## SUPPLEMENT TO INVITATION FOR BID – April 8, 2019 City of Craig

## CRAIG NORTH COVE HARBOR LIGHTING REPLACEMENT RESPONSE TO QUESTIONS - SECOND SET

Photos of typical mounts

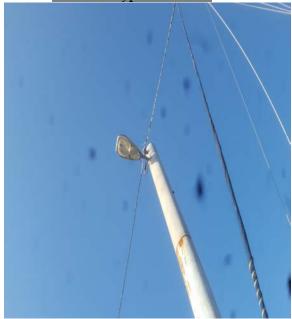
- Q4. There are wood and steel piles, are SS through-bolts required for each type of pile or can lag bolts be used on wood piles?

Response: The mounts that are on the wood piling are galvanized through bolts. New wood piling mounts to match. The steel piling should mounts shall be SS through bolt. Photographs of typical wood piling and steel piling mounts are attached.
